Addendum #3, May 30, 2025

Invitation to Bid (ITB) #2505 YVC Building 2 Tenant Improvement
NEW ITB Close Date/Time: June 12, 2025, 1:00 pm, Local Time

This addendum forms a part of the Contract Documents and modifies the original Construction Documents dated 04/25/25 as noted below, and becomes a part of the Contract Documents.

DEMOLITION FLOOR PLAN - AREA B - MECHANICAL

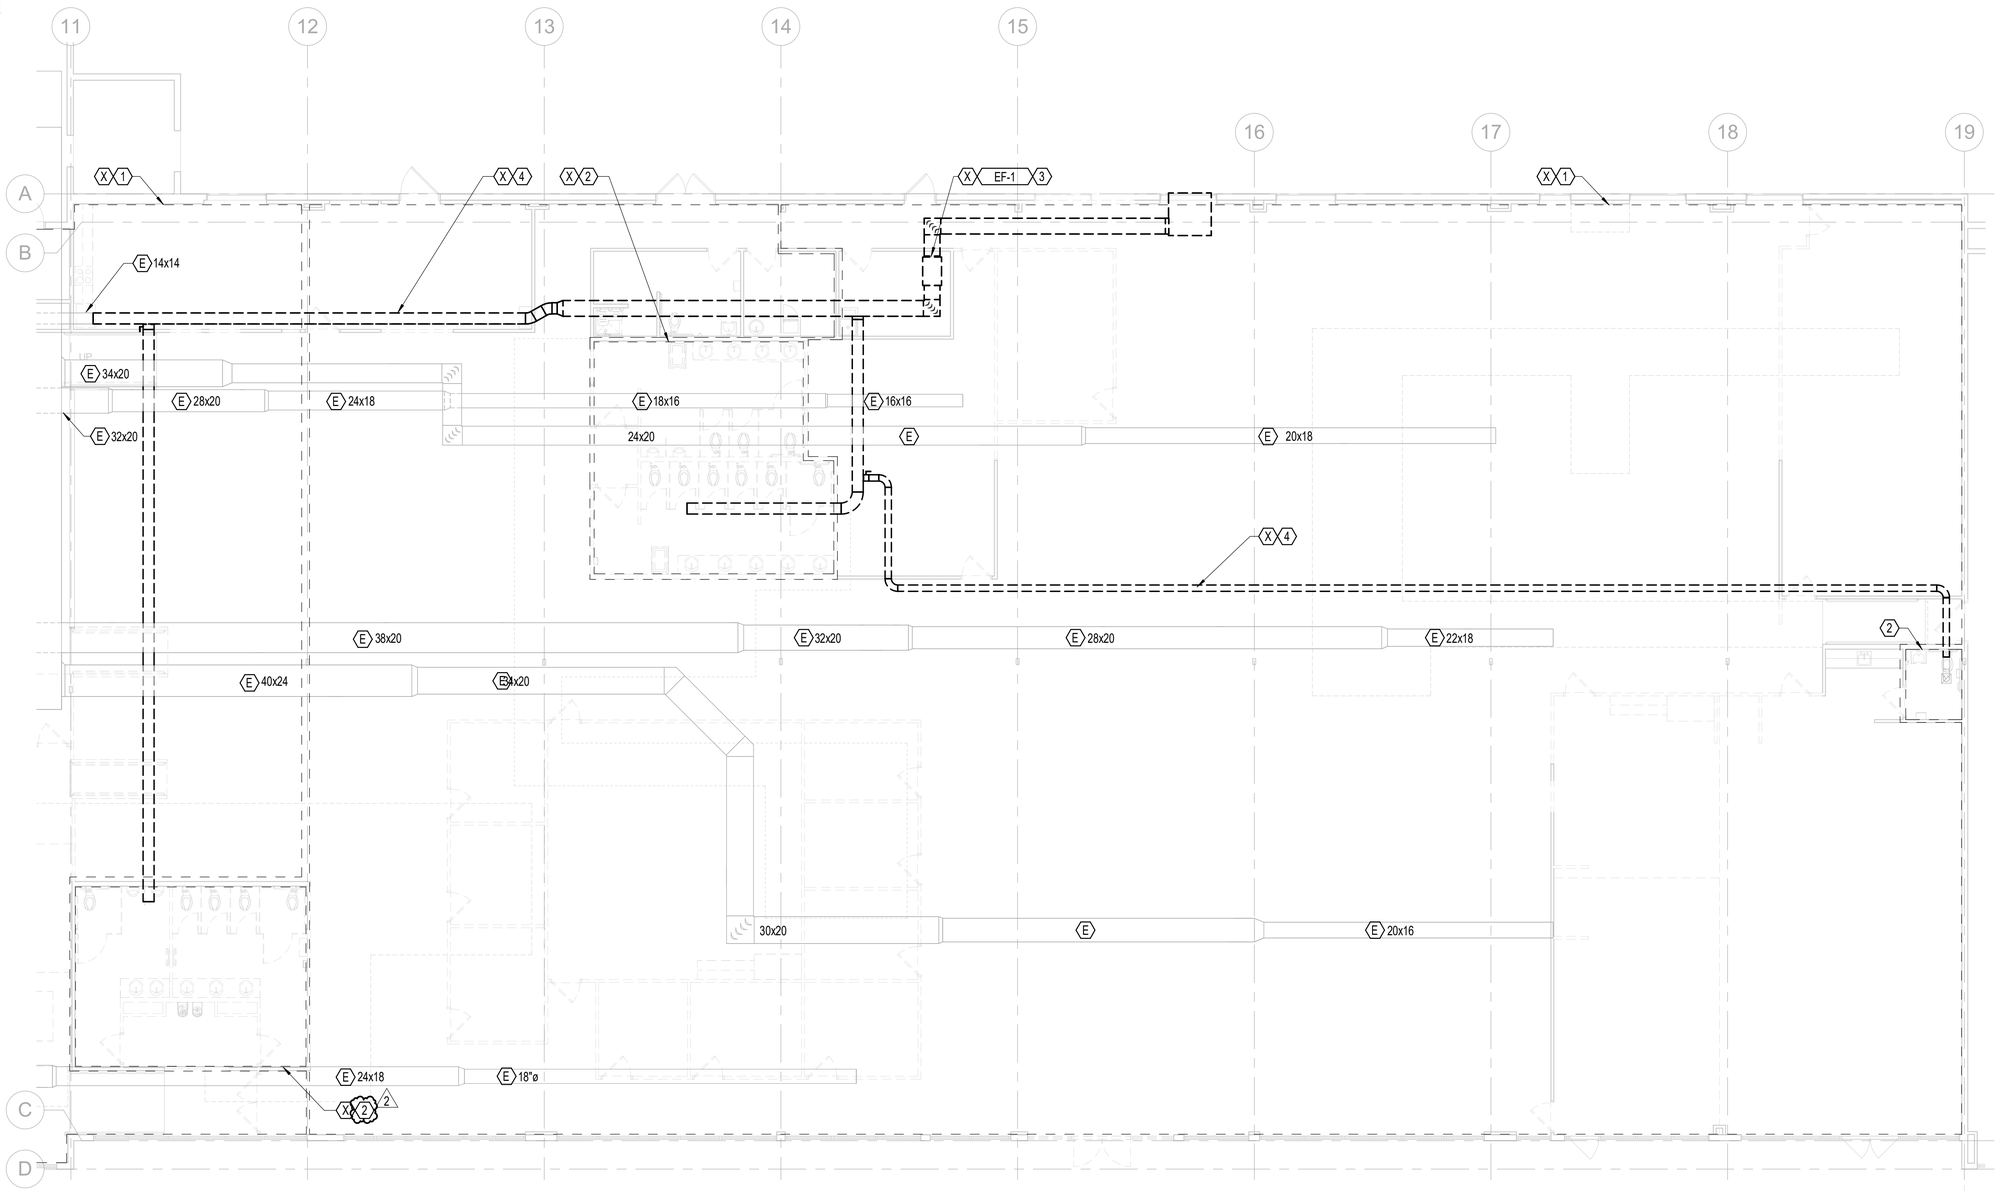
9. **Question:** Keynote 5 is listed on M-101B along gridline 12. There is no keynote 5 listed in the keynotes section. Please provide clarification on keynote 5.

Answer: Keynote should be keynote 2. Demolish exhaust ductwork and grilles serving existing restroom. Refer to updated drawing.

sheet M-102B

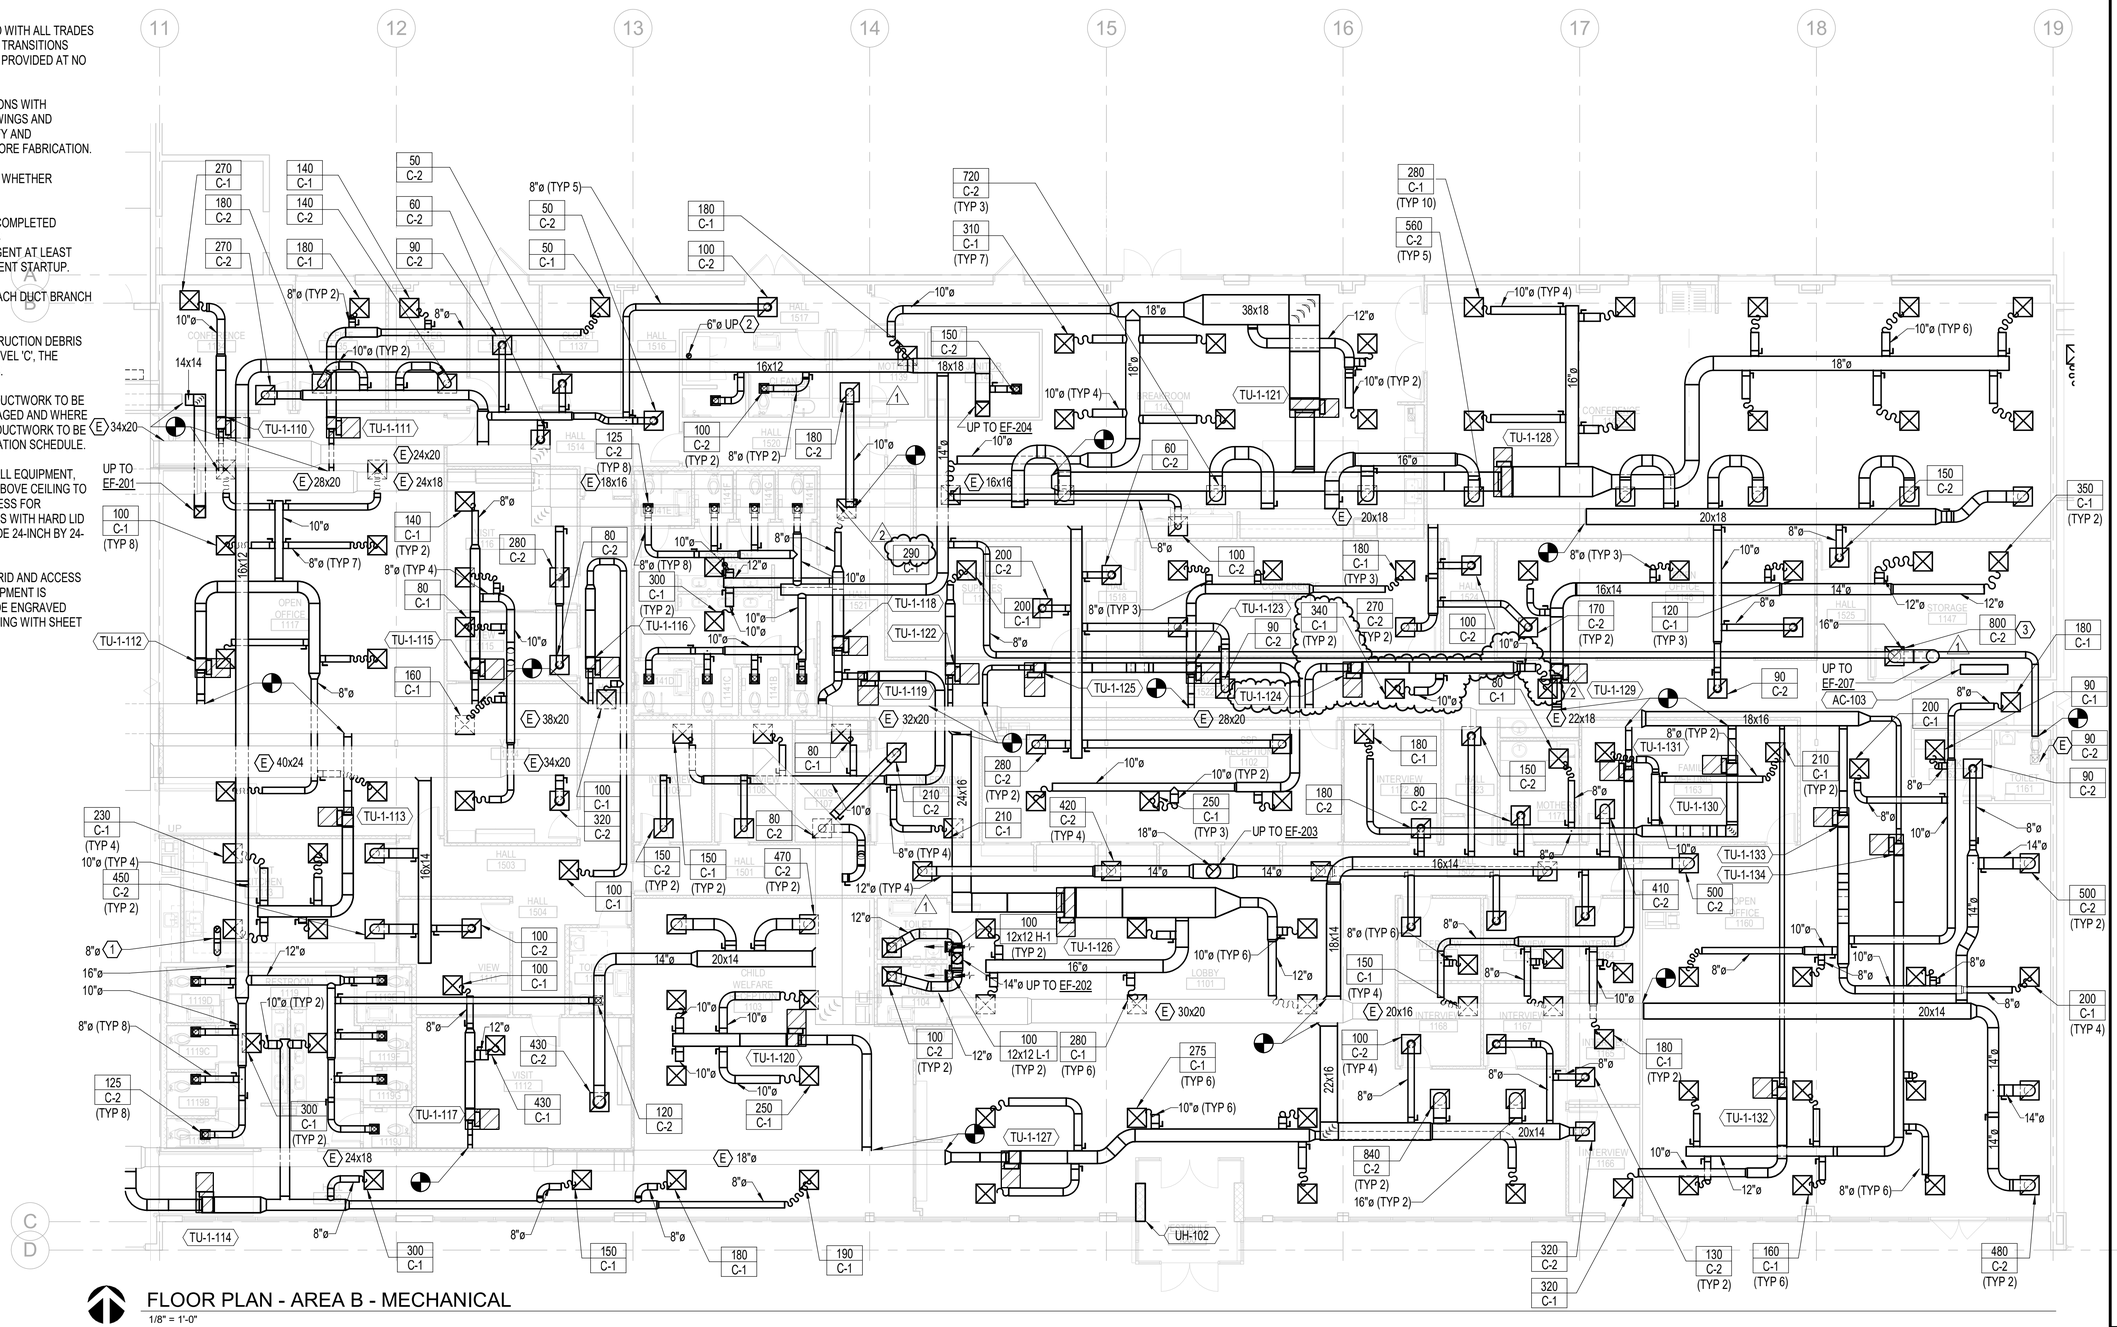
1. Sheet M-004: Replace this sheet in its entirety. Schedule revisions.
2. Sheet M-101B: Replace this sheet in its entirety. Revised construction note.
3. Sheet M-102B: Replace this sheet in its entirety. Various plan revisions.

sheet: E-102B
of:

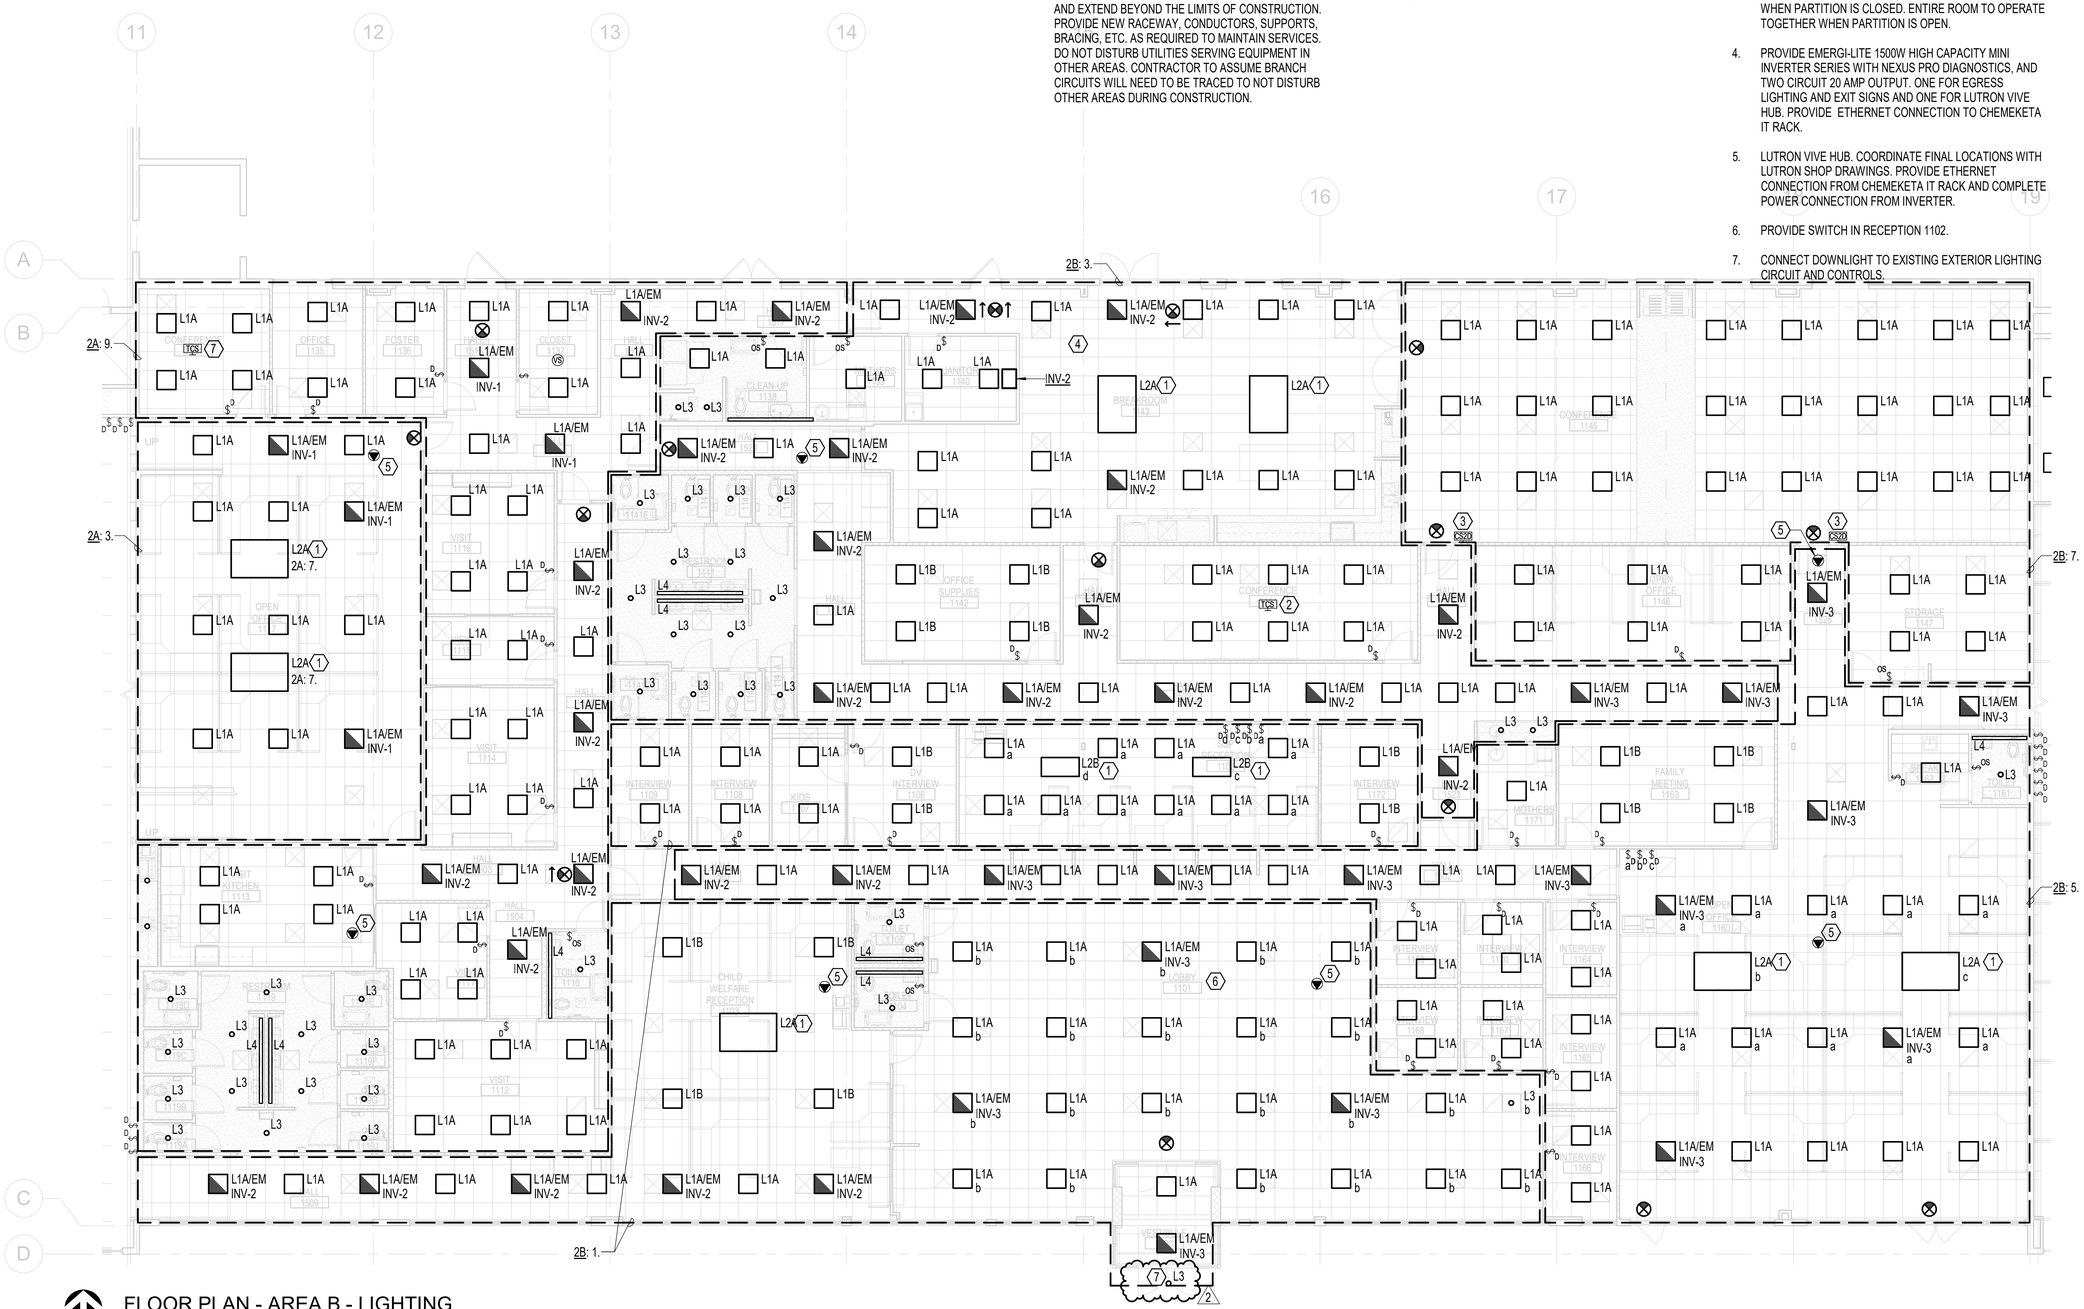
1. Sheet E-102B: Replace this sheet in its entirety. Added downlight at vestibule.
2. Sheet E-103A: Replace this sheet in its entirety. Revised circuiting and plan changes.
3. Sheet E-103B: Replace this sheet in its entirety. Revised notes and plan changes.
4. Sheet E-103C: Replace this sheet in its entirety. Revised notes and plan changes.
5. Sheet E-104A: Replace this sheet in its entirety. Revised general notes.
6. Sheet E-104B: Replace this sheet in its entirety. Revised notes and device locations.
7. Sheet E-104C: Replace this sheet in its entirety. Revised general notes.
8. Sheet E-401: Replace this sheet in its entirety. Revised circuiting and device locations.
9. Sheet E-801: Replace this sheet in its entirety. Revised panel schedules.
10. Sheet E-802: Replace this sheet in its entirety. Revised panel schedules.
